June 05, 2020

Dear Libertyville Permit Commission,

TOPOGRAPHICAL SITE DEVELOPMENT PLAN

LOTS 56 AND 57 IN OAKWOOD TERRACE, A SUBDIVISION OF PART OF LOTS 20, 21, 22 AND 23 IN SCHOOL TRUSTEES' SUBDIVISION OF SECTION 16 AND A PART OF THE NORTHWEST 1/4 OF SECTION 21, TOWNSHIP 44 NORTH, RANGE 11, EAST OF THE THIRD PRINCIPAL MERIDIAN, ACCORDING TO THE PLAT THEREOF RECORDED MAY 28, 1924 AS DOCUMENT 240473, IN BOOK "N" OF PLATS PAGE 3, LAKE COUNTY, ILLINOIS.
 COMMON ADDRESS: 309 FOREST LANE, LIBERTYVILLE, ILLINOIS
 PIN NO. 11-16-309-005, 11-16-309-006, 11-16-309-022

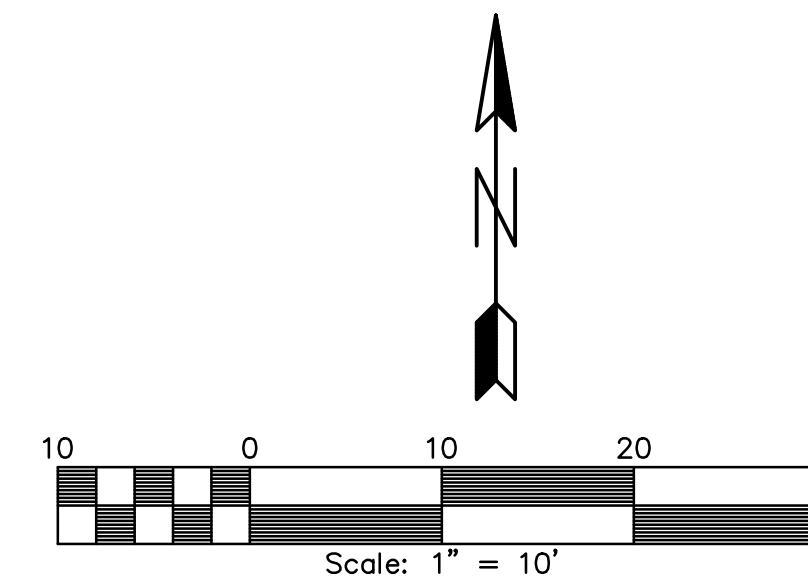
Thank you for your time in the last meeting. We appreciate your guidance and have adapted our vision to incorporate your feedback. The following summarizes the changes made in our proposal plans:

- Pool and related patio smaller by 3" (114 sf)
- Removing entire front driveway
- Removing entire second front walkway
- Removing walk from upper rear patio to lower area
- Keeping all the removals/replacements to the large driveway per the previous version
- Pool and patio and retaining and fencing are 3' further from the Sunset/western lot line than the previous version

The above proposed amendments have changed the proposal to be below the existing coverage (now 40.2%) and conform to the lot coverage requirement. Additionally, these proposal changes align with the 3 proximity variance requests *further* from the western lot line than before, thus reducing those variations.
